On June 15, 1992, the Department received a PSD permit application to construct a 206 MW cogeneration power plant at the U.S. Agri-Chemicals Complex near Ft. Meade, Florida and deemed it incomplete. Please provide the following information:

RE: Central Florida Power Limited Partnership, Central Florida Cogeneration Plant (PSD-FL-190)

Tiger Bay (formerly Central Florida) cogeneration plant

PSD-FL-190 AC 53-214903

Figure 1 TIGER BAY CONCEPTUAL DRAWING OF STACK AND ADJOINING STRUCTURE

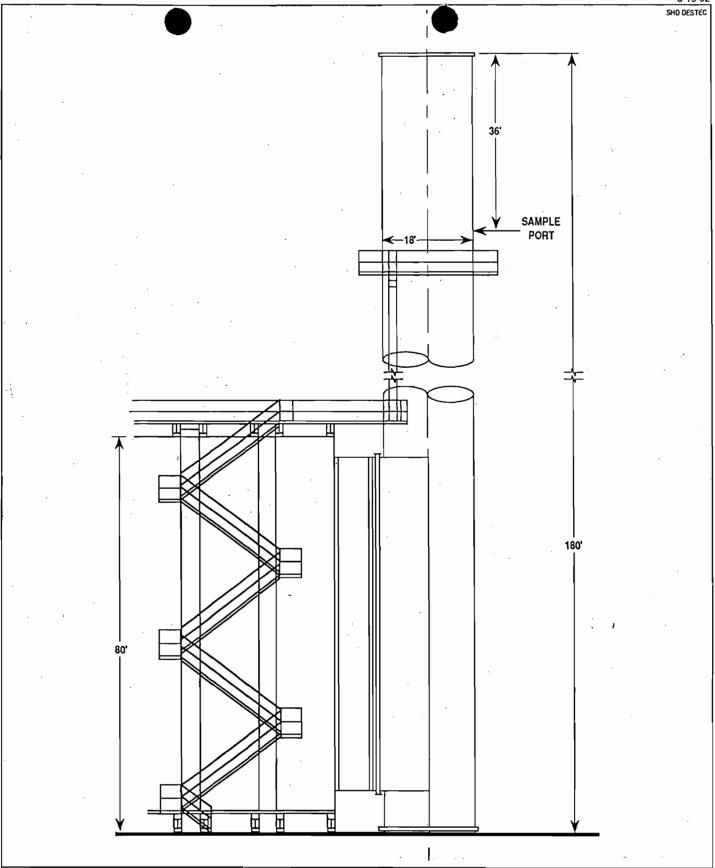
12. COMMENT (via July 15, 1992, telephone conversation): Please provide a diagram indicating the proposed location of the sample ports for source sampling purposes. Show these locations with respect to the proposed stack and HRSG unit.

RESPONSE: The stack sample port location is depicted in Figure 1. The sample port will be accessible by ladder from the top of the HRSG to a platform assembly near the port location.
